**GENOA CHARTER TOWNSHIP  
PLANNING COMMISSION  
PUBLIC HEARING  
DECEMBER 12, 2022  
6:30 P.M.  
AGENDA**

<b>Attention:</b>	Amy Ruthig, Planning Director
<b>Subject:</b>	Wonderland Marine – Special Land Use and Site Plan Review #2
<b>Location:</b>	5796 Grand River Avenue – south side of Grand River, west of Dorr Road
<b>Zoning:</b>	GCD General Commercial District and TCOD Town Center Overlay District

**Re: Wonderland Marine Showroom  
Site Plan Review No. 2**

# PROPOSED SITE PLAN FOR WONDERLAND MARINE WEST NEW SHOWROOM AND SALES OFFICE

**SIDEWALK CROSS SECTION**  
NOT TO SCALE

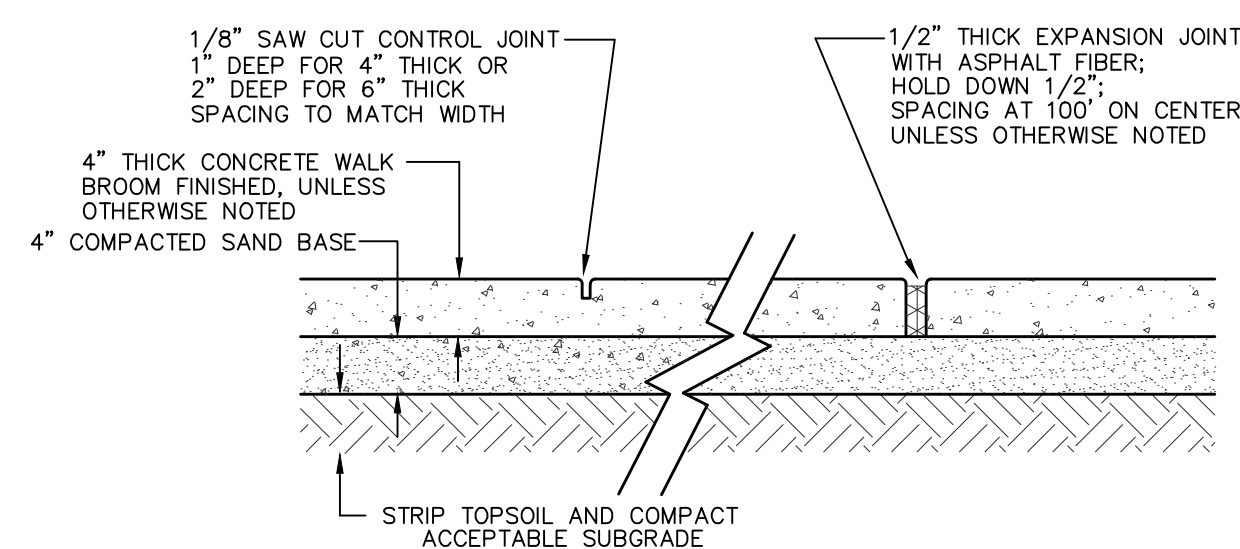
1. The sidewalk cross section should be updated to show 6 inches of MDOT CLII sand subbase.

NEW HIGH BAY BOAT SHOWROOM for:  
**WONDERLAND MARINE WEST**  
 GENOA TWP., MI  
**ELEVATIONS**

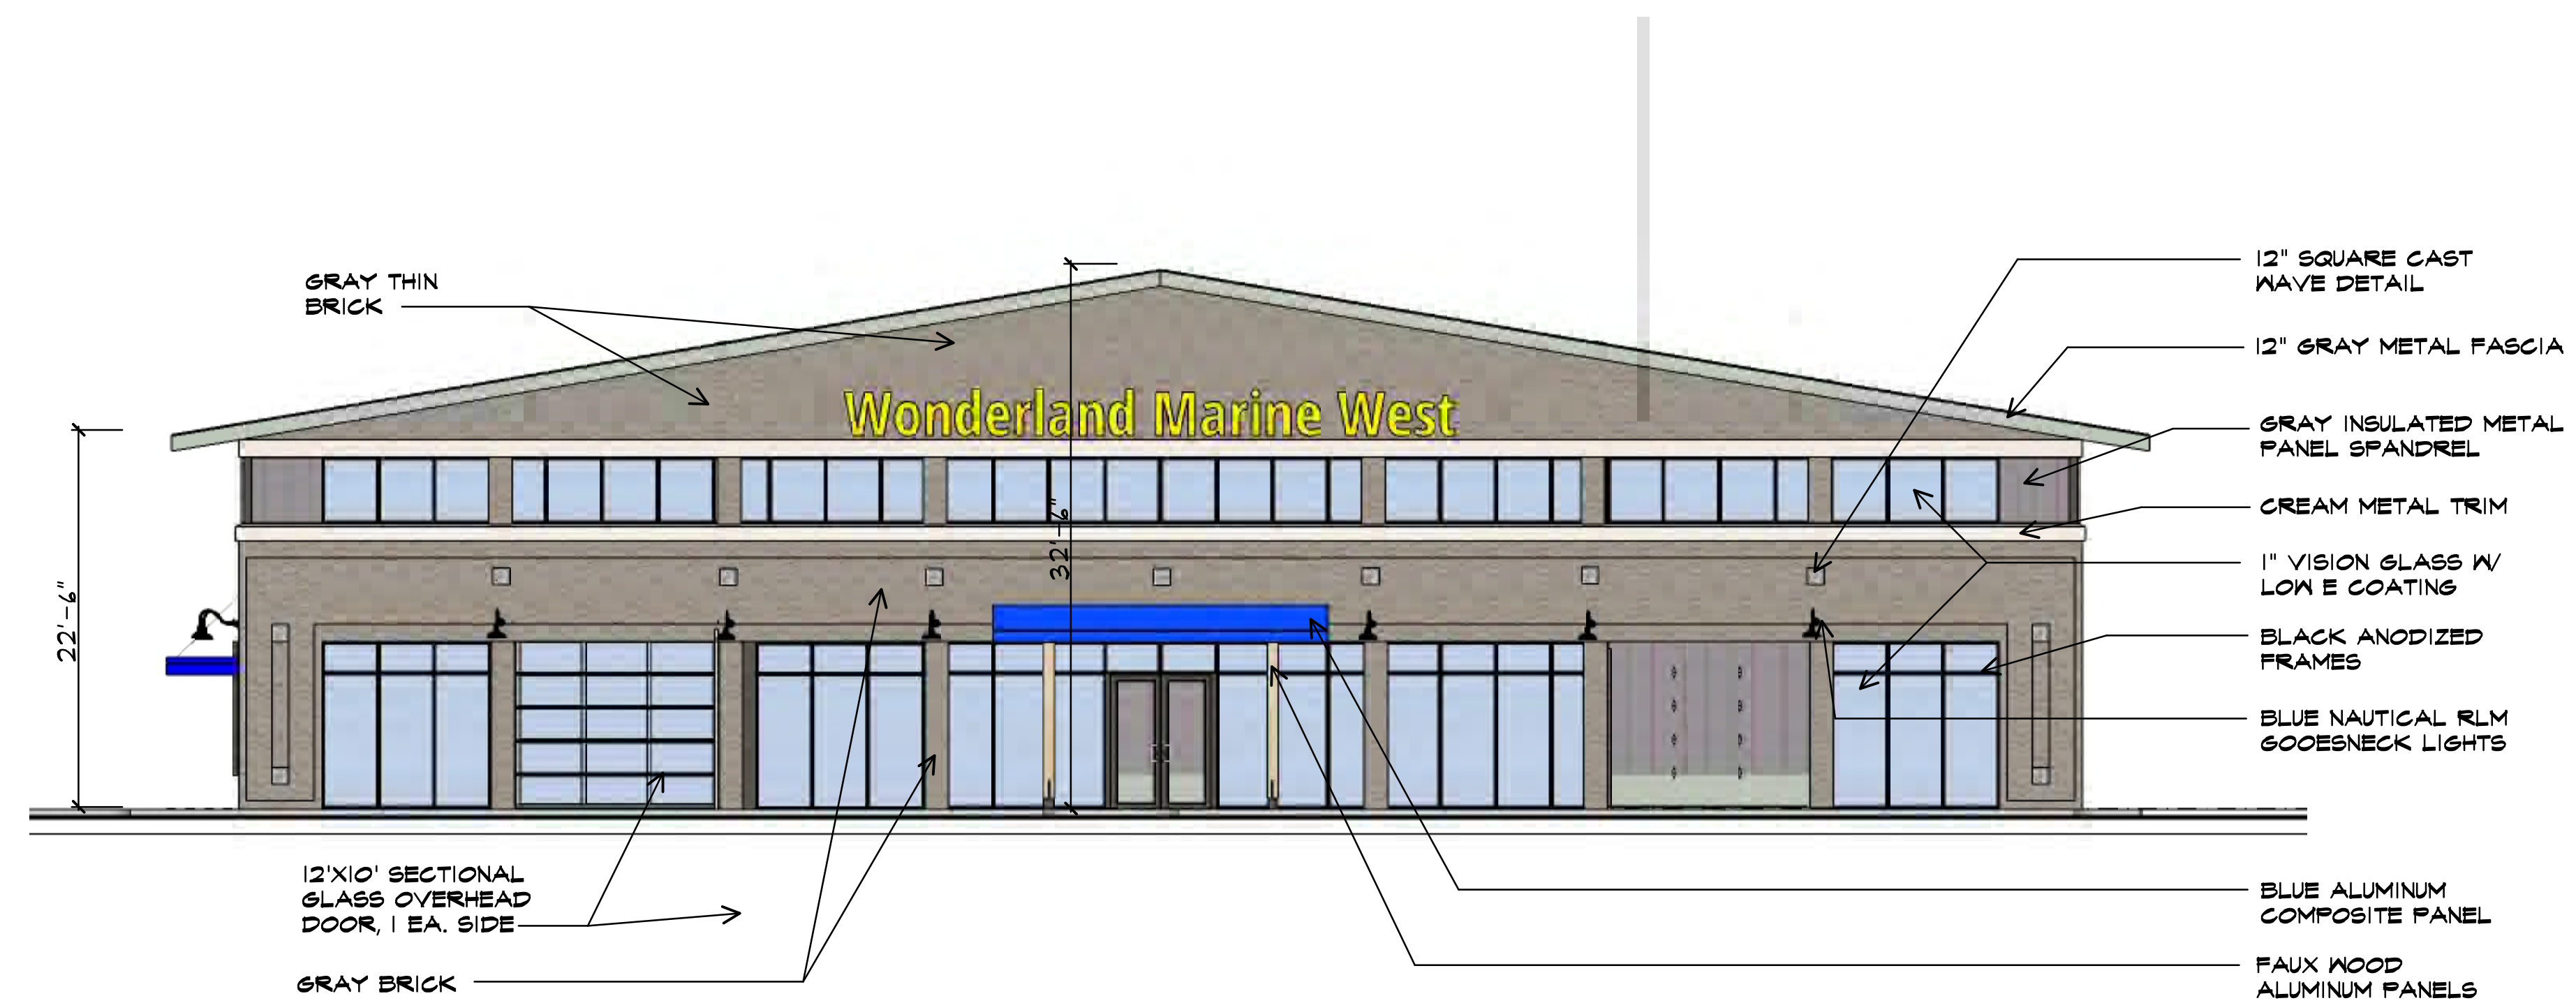
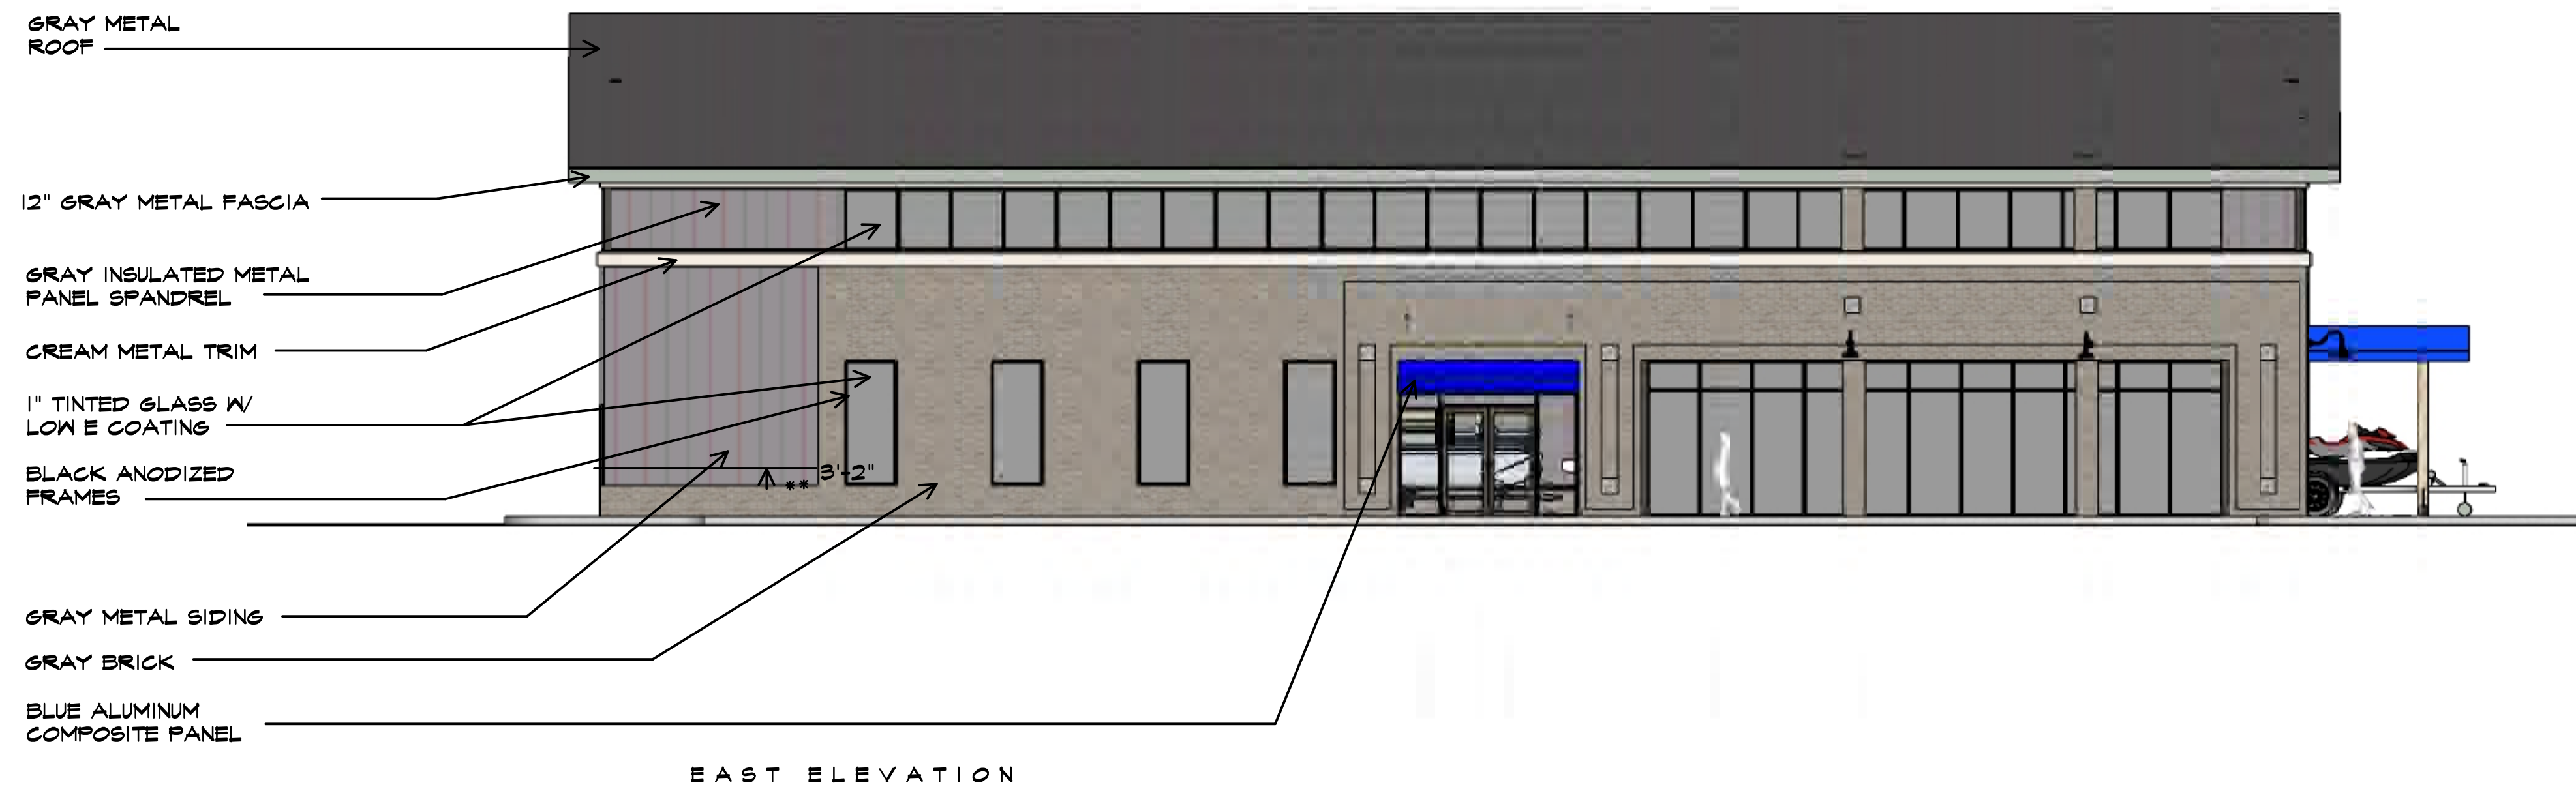
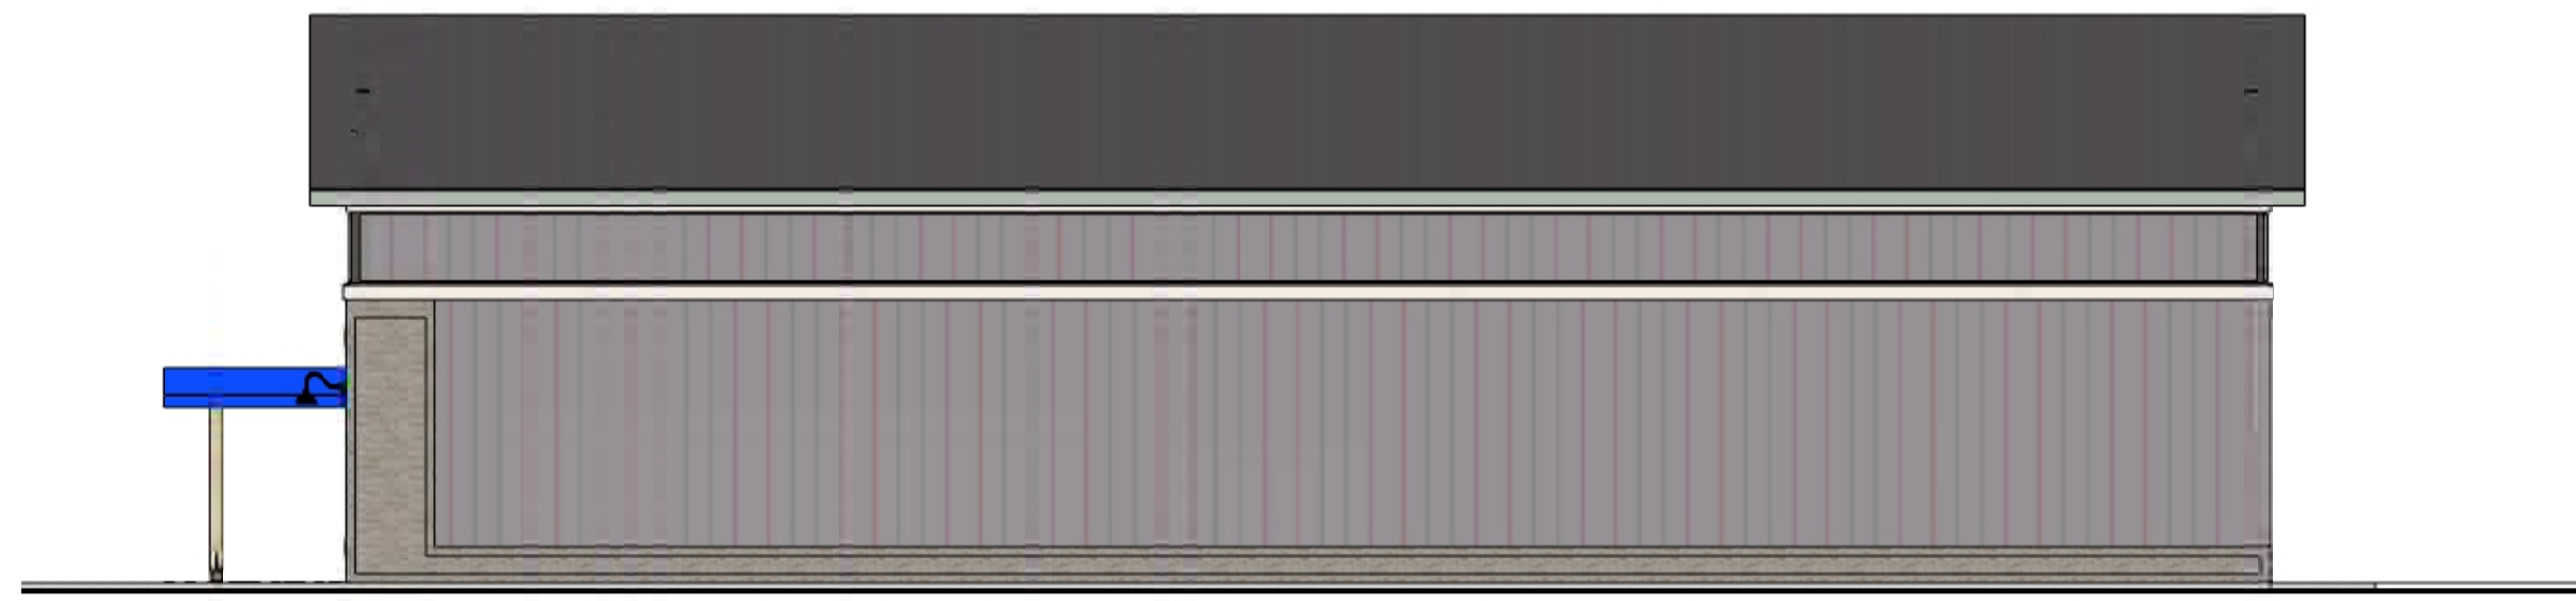
- Building types – non-residential buildings shall be designed with traditional styles of architecture, similar to that found in downtown Brighton and Howell. In our opinion, the proposed building does not bear any resemblance to the traditional architecture found in downtown Brighton or Howell. The project architect may wish to provide the Township with more information to help determine compliance.

- Front façade – entrances are to be located on the street frontage, and include design details; buildings longer than 100’ shall provide architectural variation to break the building up. The entrance on the front of the building is covered with a canopy; however, there are no architectural variations to speak of for the 110’ wide building. Additionally, there is an overhead door incorporated into the front façade, which is not typically permitted anywhere in the Township.

- Building materials – 75% of facades facing the street or parking areas are to be brick or stone. The front (north) and east (side towards parking lot) facades are predominantly brick. The revised submittal includes calculations demonstrating compliance with this standard.

- Roof design – Planning Commission may permit a pitched (gable) roof; eaves shall not be lower than 20’. The gable roof requires Commission approval, though the eave line complies with the 20’ minimum requirement.
